VOLUME III
FINAL ENVIRONMENTAL IMPACT STATEMENT
CONSTRUCTION AND OPERATION OF
TITAN IV/CENTAUR LAUNCH COMPLEX

VANDENBERG AIR FORCE BASE, CALIFORNIA
AUGUST 1990

- (d) Responsible Individual: Mr. John Edwards
HQ SSD/DEV
P.O. Box 92960
Los Angeles, California 90009-2960
Telephone: (213) 643-0934
- (e) Designation: Final Environmental Impact Statement (Final EIS)

FIGURE 2.1.2

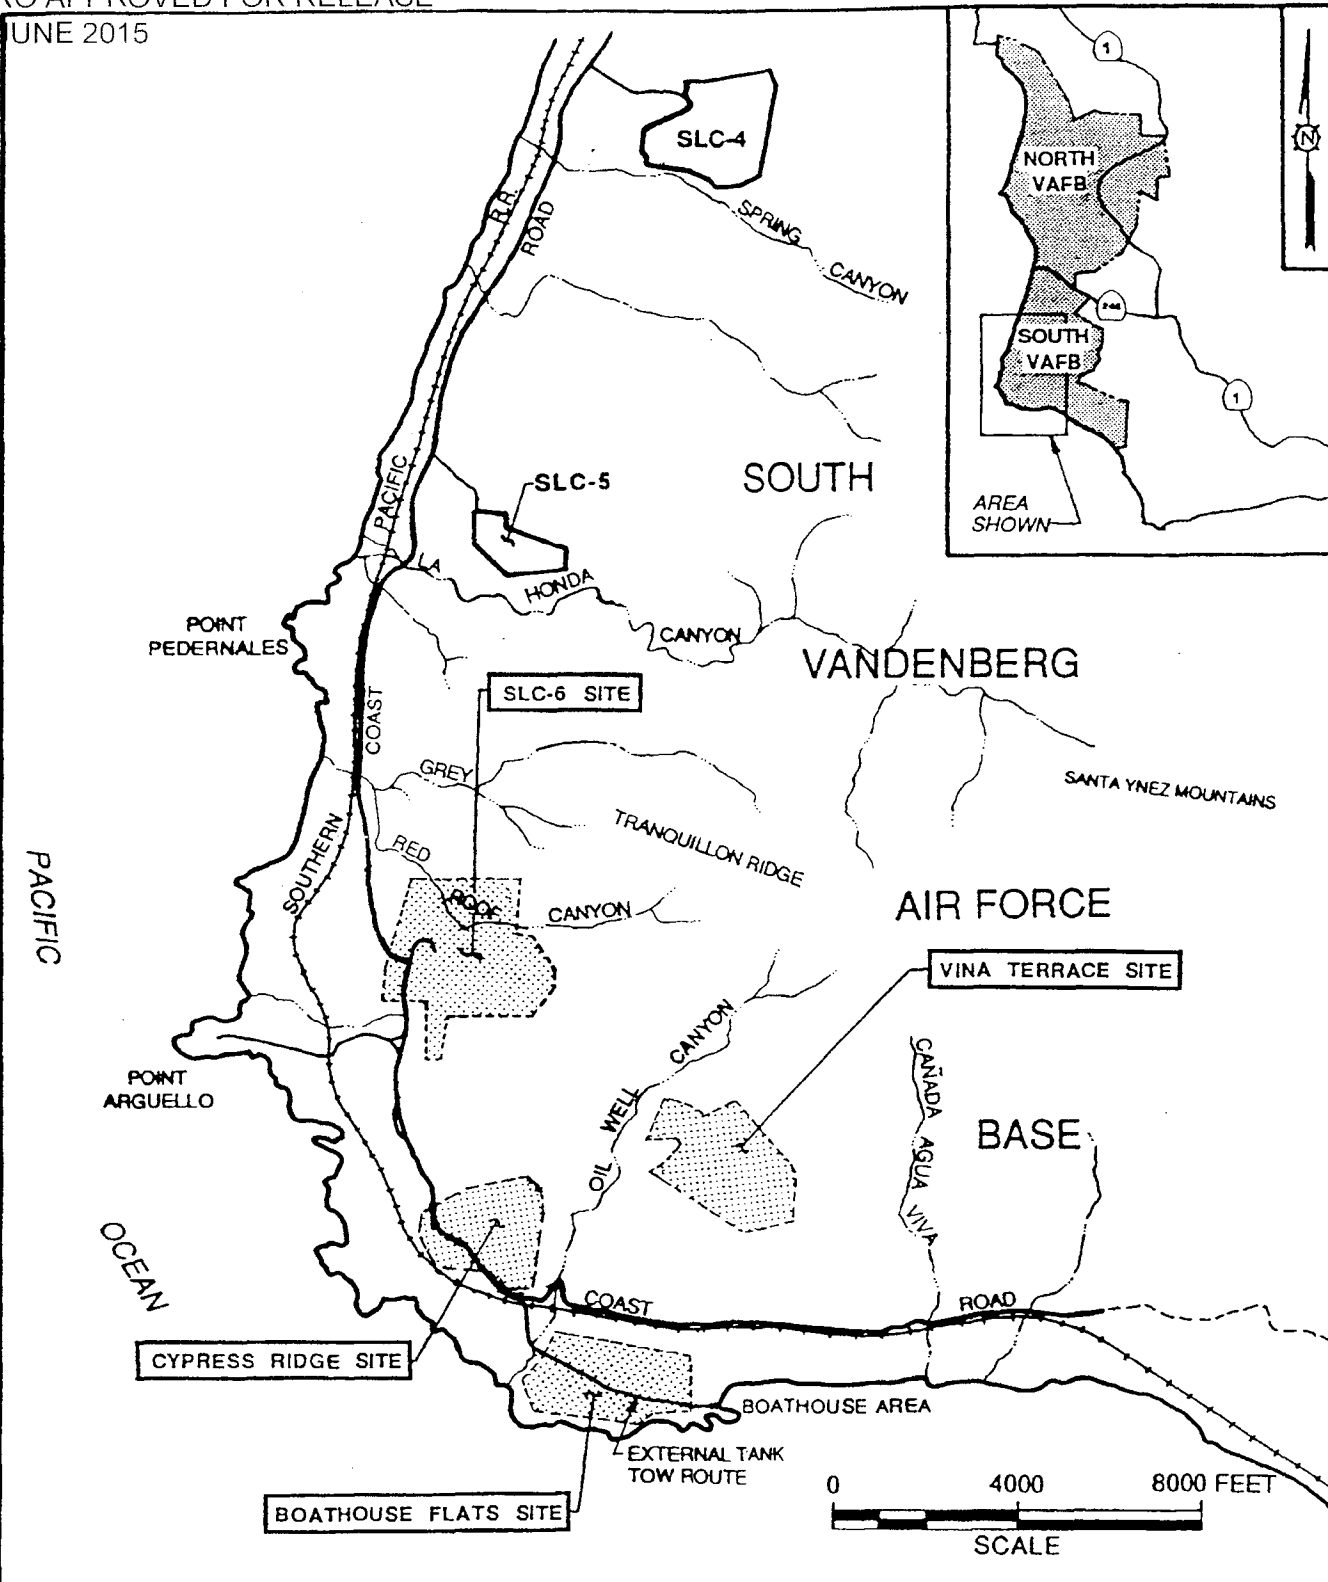
- [102] 14. Page 2-22, last para., RE: Quantity-Distance Criteria. The "safety clear zones" referred to here do not appear to be shown in Figure 2.1.2 (Proposed Cypress Ridge Site and Alternatives) for existing space launch complexes.

Comment No. 102: Safety Zones for Figure 2.1.2 (Proposed Cypress Ridge Site and Alternatives)

Section 2.1.3.5, page 2-22, fourth paragraph, sixth and seventh lines, delete "Safety clear zones determined by these criteria are shown for existing space launch complexes and the proposed SLC-7 in Figure 2.1.2."

FIGURE 2.1.11

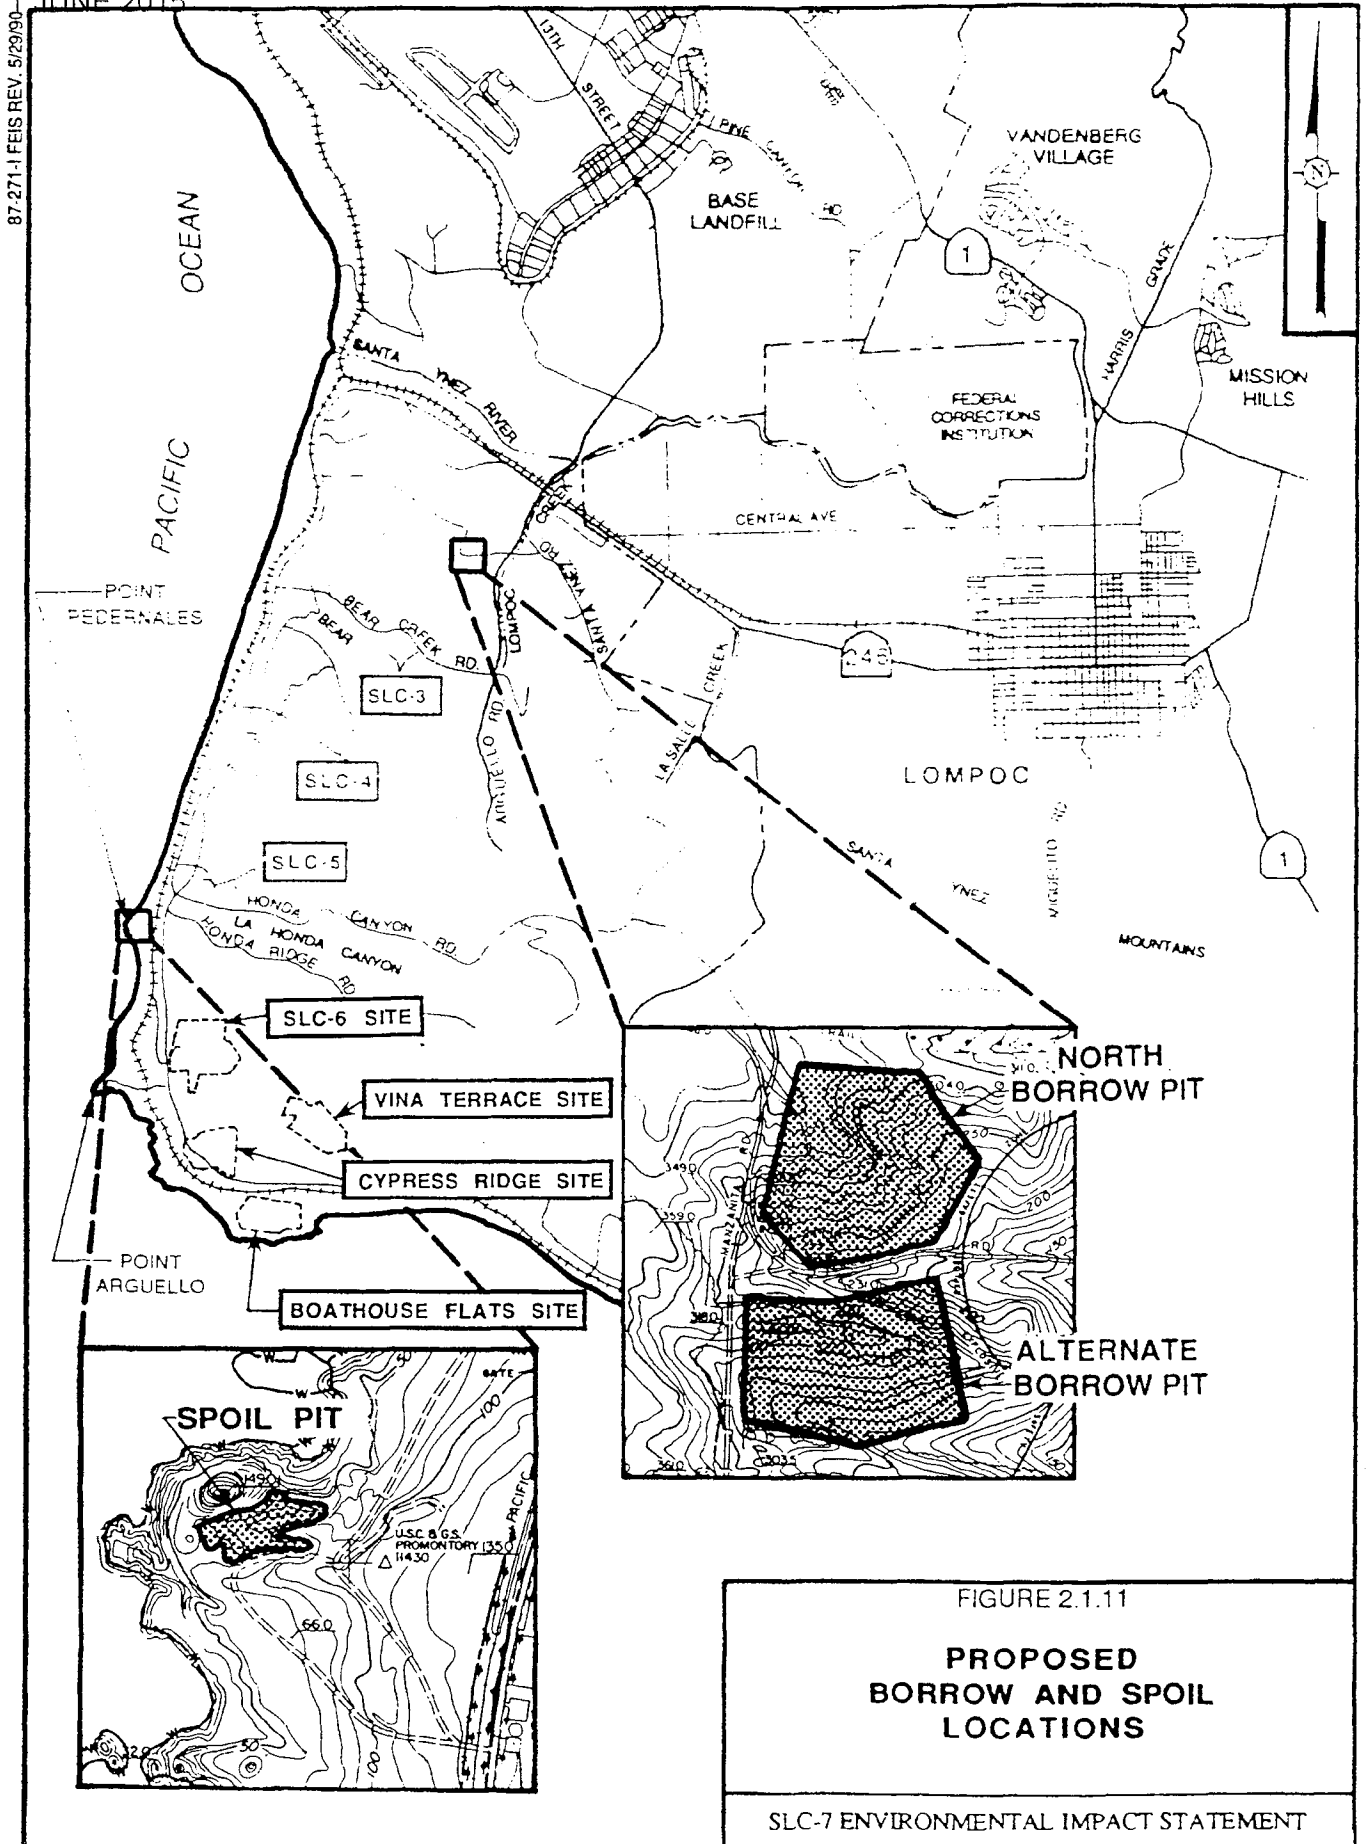
[44] Page 2-25 - More information is needed on the locations of the proposed borrow and spoil pits indicated in Figure 2.1.11. Borrow areas adjacent to the Santa Ynez River may contain riparian/wetland resources which could be impacted by borrow activity. This needs clarification.

The potential borrow pits adjacent to the Santa Ynez River are no longer being considered as areas that would be utilized as a source of construction material for the proposed action. A revised Figure 2.1.11 is provided in Section 3.3 of the Final EIS.

The potential borrow pits adjacent to the Santa Ynez River are no longer being considered as areas that would be utilized as a source of construction material for the proposed action. A revised Draft EIS Figure 2.1.11 is provided in Section 3.3 of the Final EIS.
